Our reference: P-987097-L5X1
Contact: Tania Shephard
Telephone: (02) 4732 7797

Council Response to Notice of Exhibition – DA25/7071 (PAN-560090) – Penrith Lakes – Tourism Oriented Development Concept and Early Works – 39-45 and 47 -65 Old Castlereagh Road Penrith 2750 (Lot 12, 14 & 16 DP 793163)

Extract of Council's Flood Mapping showing the extent of the 1% AEP mainstream flood from the 2024 Hawkesbury-Nepean Rivers Flood Study.

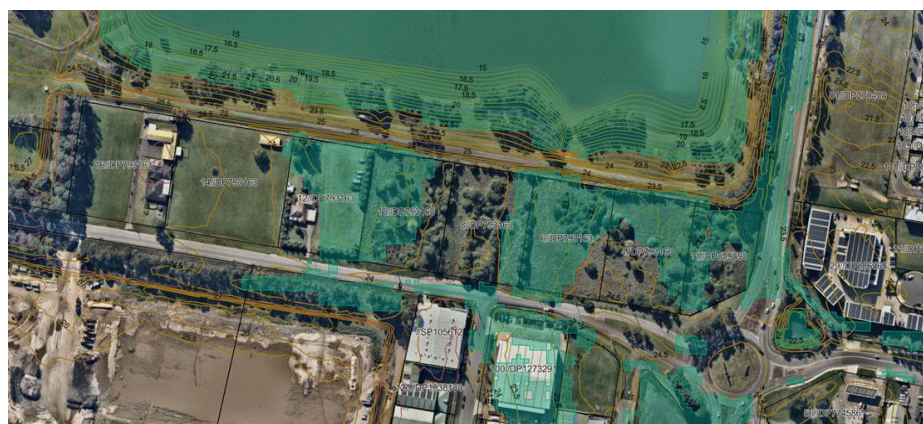
- a) The site and surrounding roads are impacted by the 1% AEP (1 in 100 year ARI) mainstream flood from the 2024 Hawkesbury-Nepean Rivers flood study. An extract of Council's flood mapping is provided below indicating roads are cut, hence evacuation routes are cut, in a 1% flood.
- b) Ordinarily, Council's planning controls do not support developments that cannot provide safe and efficient evacuation of people in a flood. (Refer to Penrith LEP 2010 Clause 5.21 *Flood Planning* and Penrith DCP 2014 Part C3.5 *Flood Planning*.) It is recommended a Flood Impact and Risk Assessment (FIRA) demonstrate how evacuation from the site is achieved in the event of a flood.
- c) It is strongly recommended that application be referred to the State Emergency Services (SES) for comment as the SES are the responsible body for flood evacuation.
